# Service Bulletin

**Subject:** Convertible Top Creak or Snap Noise While Driving

Brand:	Model:	Model Year:		VIN:		Engine:	Transmission:
		from	to	from	to		
Chevrolet	Corvette Convertible	2014	2016			All	All

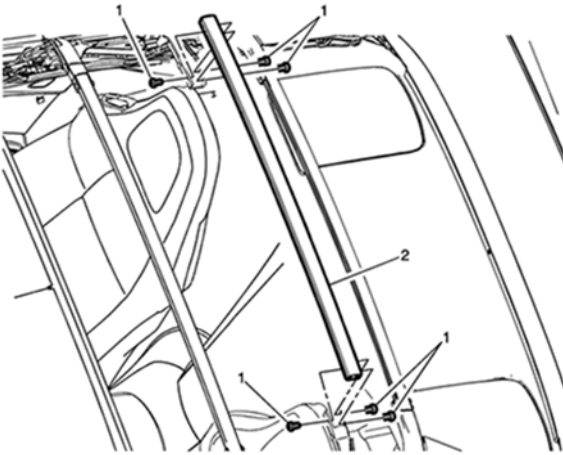
<b>Involved Region or Country</b>	North America, Japan, Europe, Middle East, Russia
<b>Condition</b>	Some customers may comment on hearing a creak or snapping noise from the convertible top while driving their vehicle. The noise may be loudest when the vehicle has sat in the sun for a length of time.
<b>Cause</b>	 <p>The cause of the condition may be that the fasteners (1) at the ends of the #3 Bow (2) may have lost torque.</p>

Following the Service Procedure below, remove the original smaller screws and install the new large M6 screws referenced in the Part Table.

- Starting on either side, replace the current M5 retaining screws with the new M6 self threading screws.

**Tighten:** Tighten the screws to 3 Y (27 lb in).
